ADDENDUM 9

Miami Lakes Library Branch

EXTERIOR IMPROVEMENTS AND COMPREHENSIVE INTERIOR RENOVATIONS

14-JUL-2025

S303

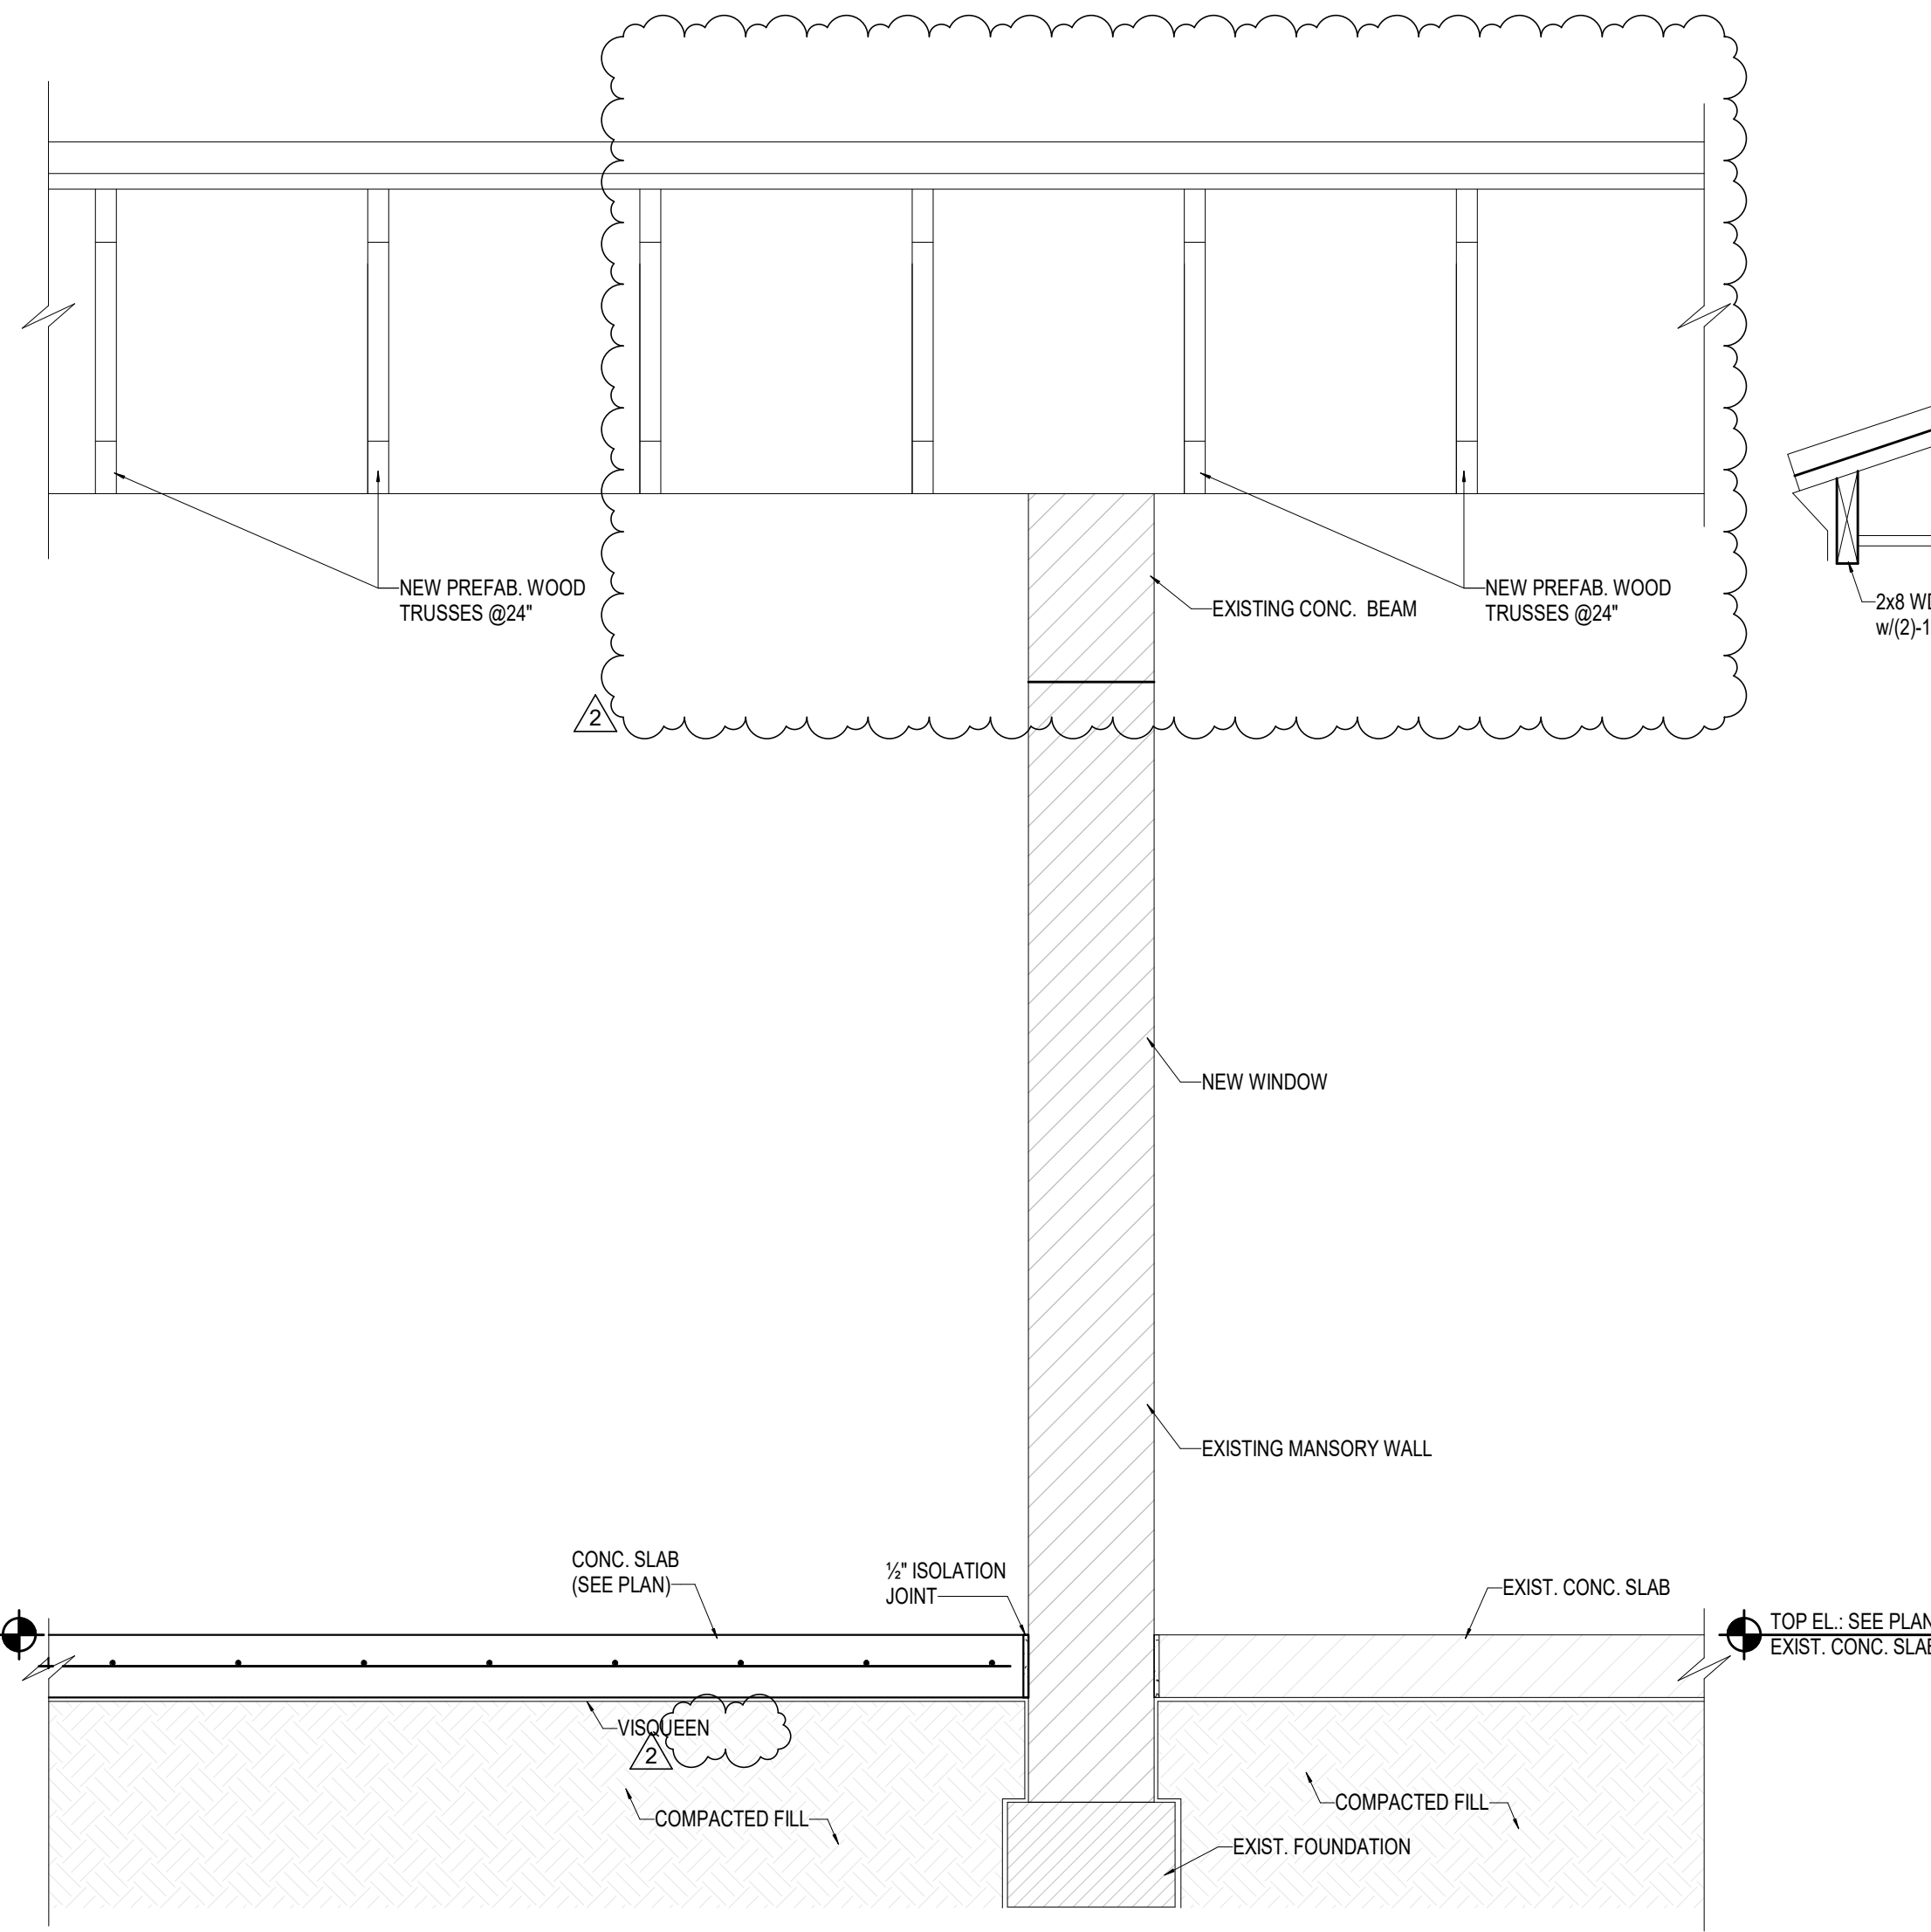
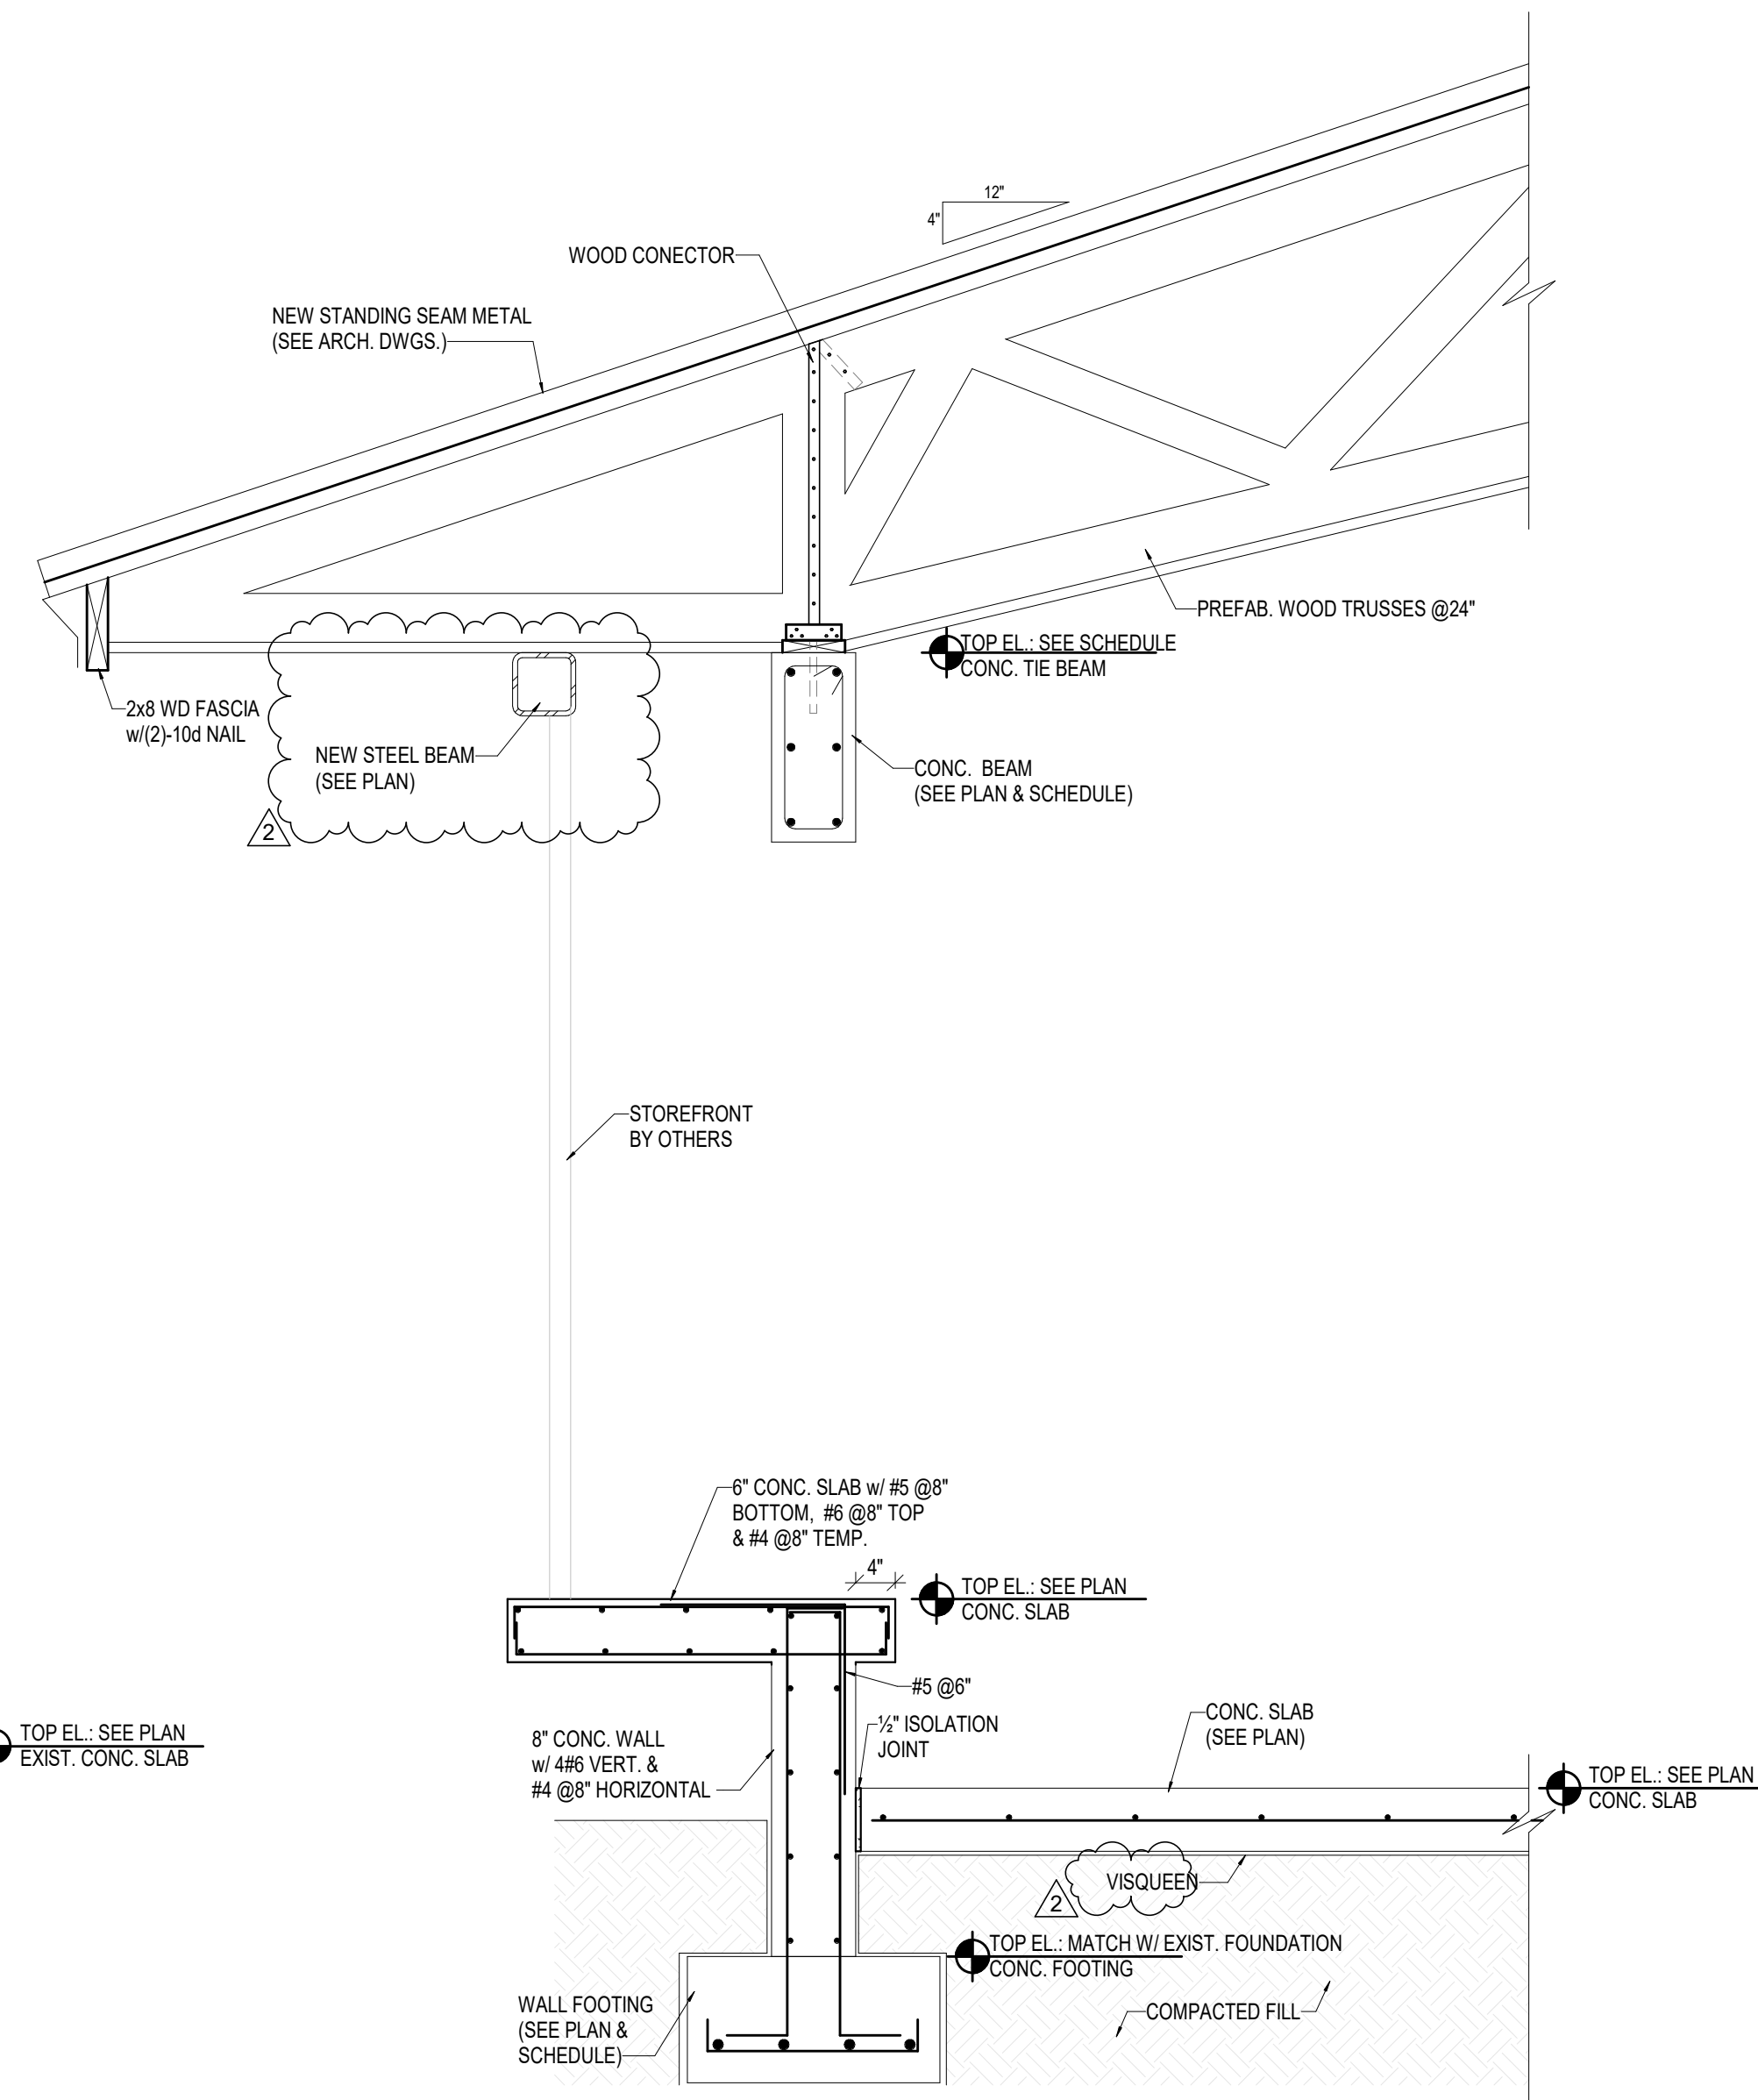
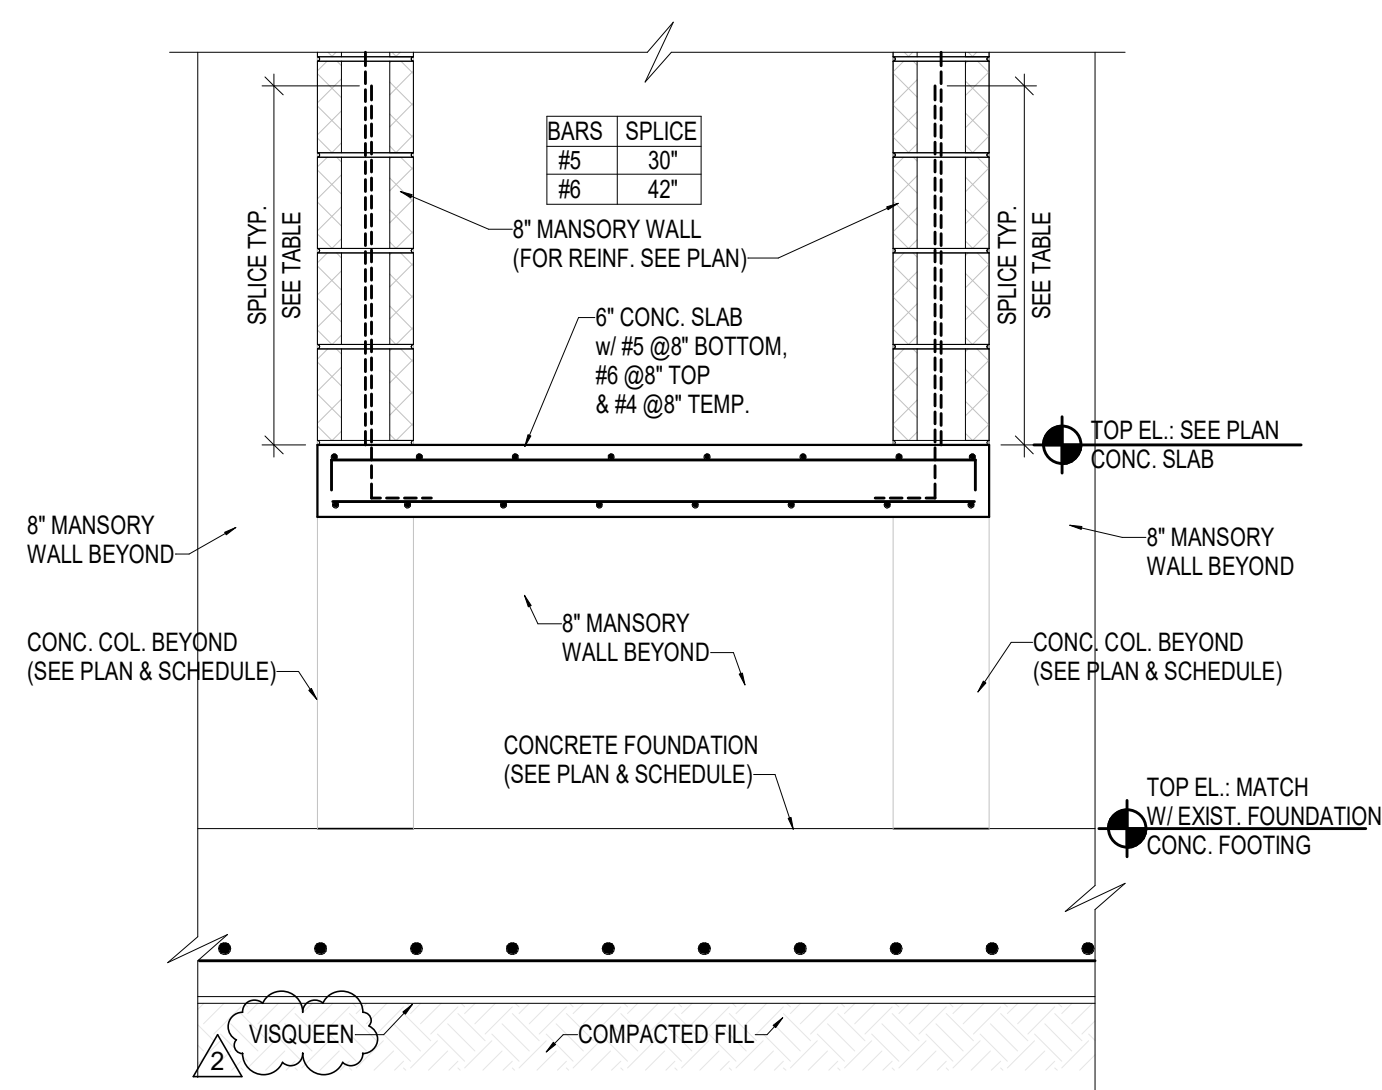
Q191. Plan Sheet S302 showing sections 4/S302 and 6/S302 do not show the steel beam required at the storefront on the corner window seats. Please add steel beams or notes regarding the structural steel columns and beams at the window seats.

A191. *The steel beams and columns are noted on Sheet S102. The steel beams above have been added to the sections on S302 and S303. All other required elements shall be included in the storefront shop drawings. GC to provide engineered shop drawings for review and approval.*
